**Curtis H. Stanton Energy Center
Combined Cycle Unit A**

Sufficiency Report

Re: Stanton Unit A Combined Cycle Project
Supplemental Site Certification Application
FDEP File No. PA 81-14SA2
DOAH Case No. 01-0416EPP
OGC Case No. 01-0176
Response to Statement of Sufficiency

Figure 6.1-1:
TLINE2
TLINE3

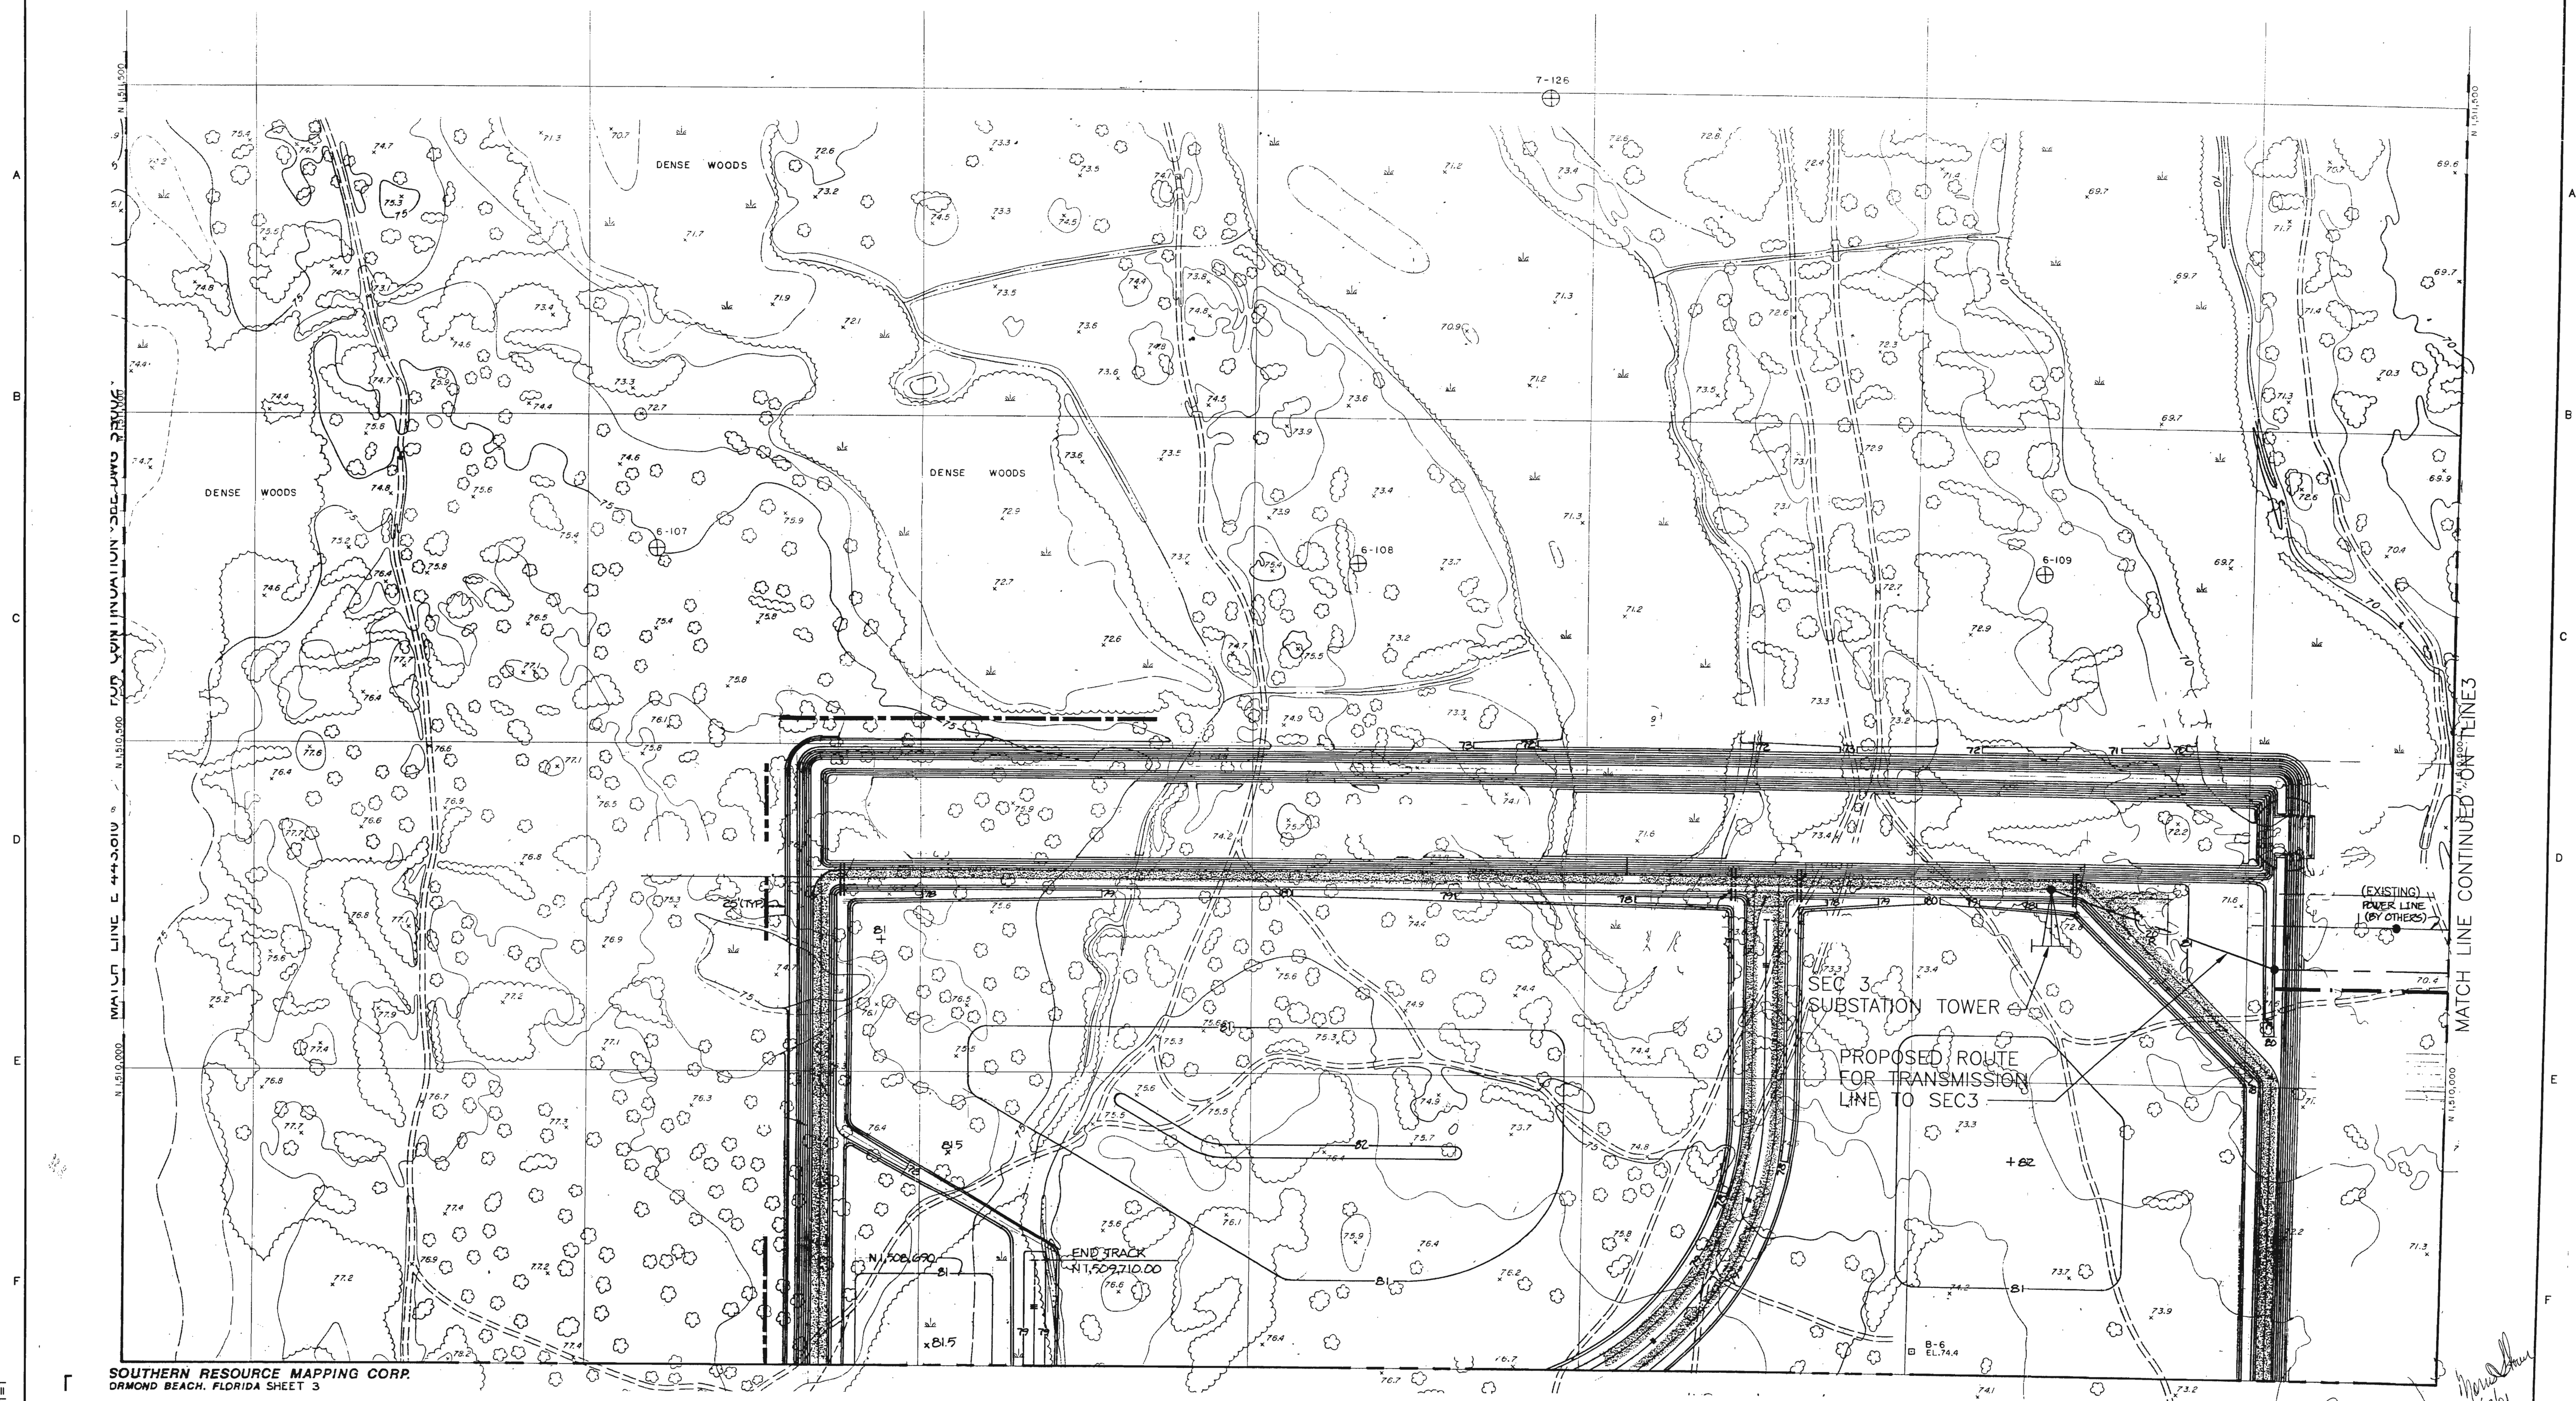
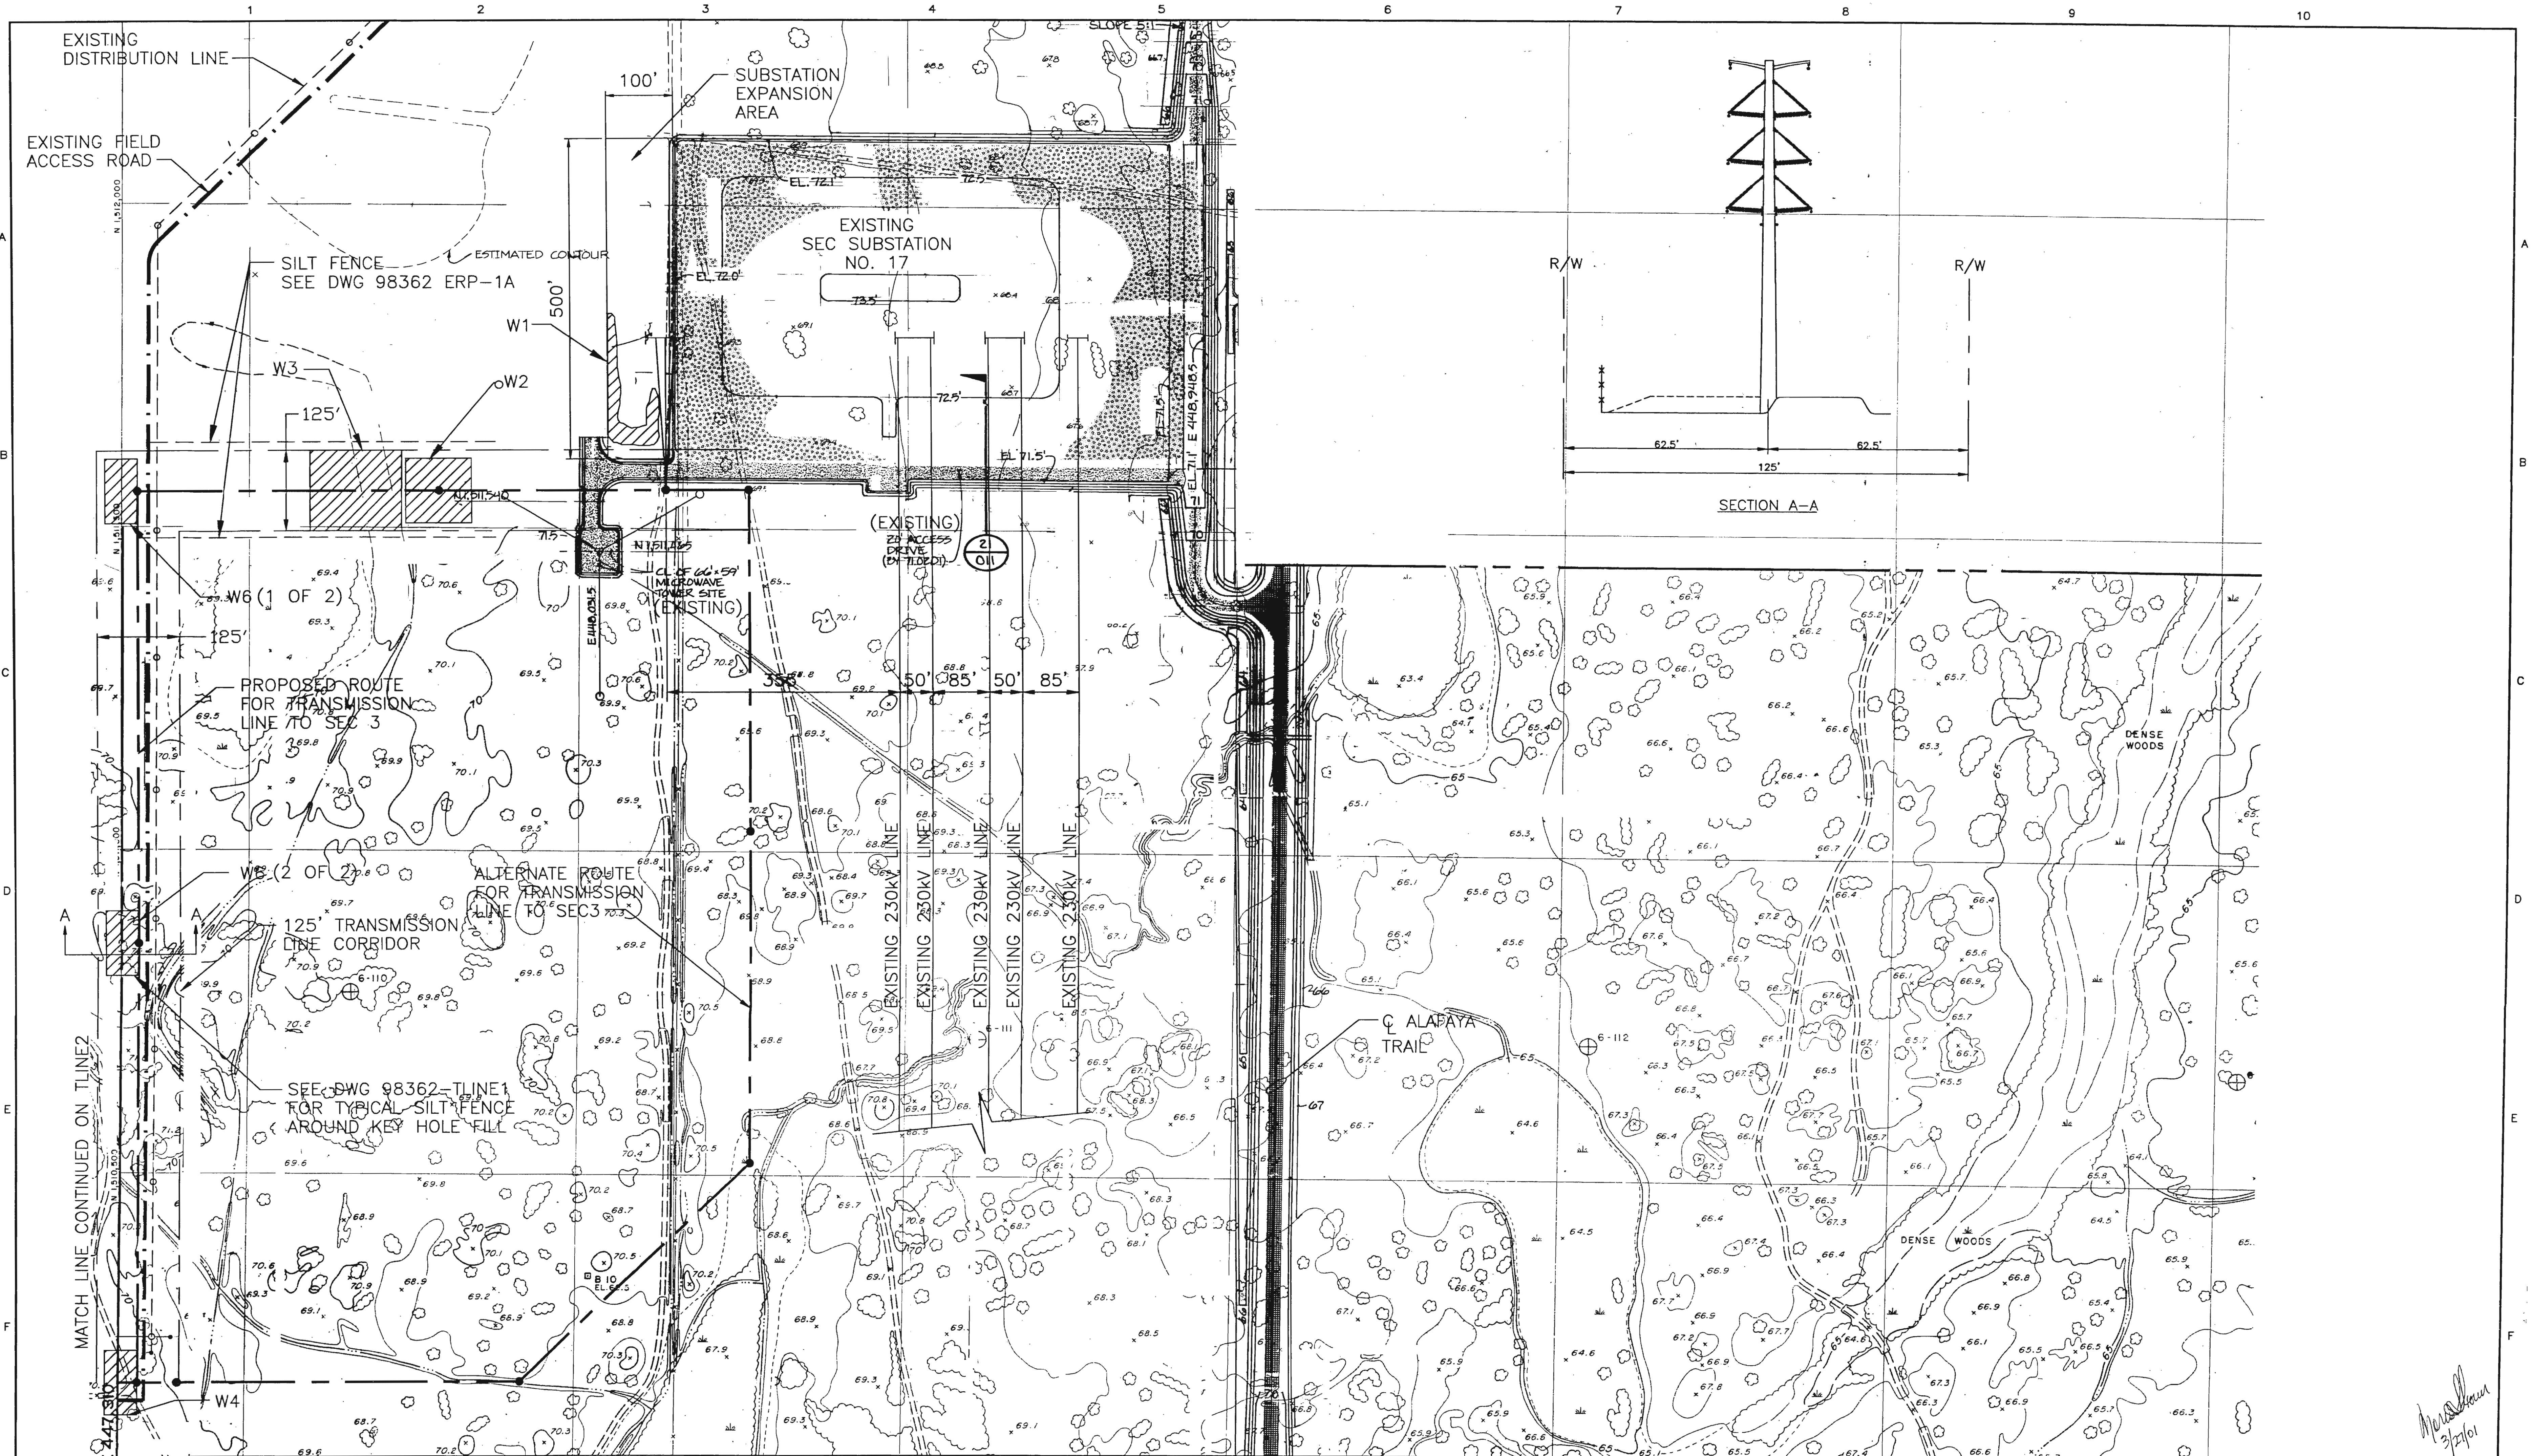
6. *Drawing Figure 6.1-1 is not legible.*

Response: Large scale drawings of the proposed and alternate transmission line routes are attached as Figure 6.1-1. The drawings have been signed and sealed.

- a) There are no named roads in the near vicinity of the transmission line, which is entirely on SEC property. The closest road is Alafaya Trail. This road is now marked on Drawing TLINE3, Figure 6.1-1, revised on March 21, 2001.

- b) The existing transmission lines going south out of the SEC Substation are now shown on Drawing TLINE 3, Figure 6.1-1.
- c) The location of the transmission centerline is shown on Figure 6.1-1.

- d) Revised Drawing TLINE3, Figure 6.1-1 illustrates the location of the wetlands, ditches, surface waters in numerical order (W-1 through W-6).
- e) Revised Drawing TLINE3, Figure 6.1-1 illustrates the size and width of the transmission line impacts.
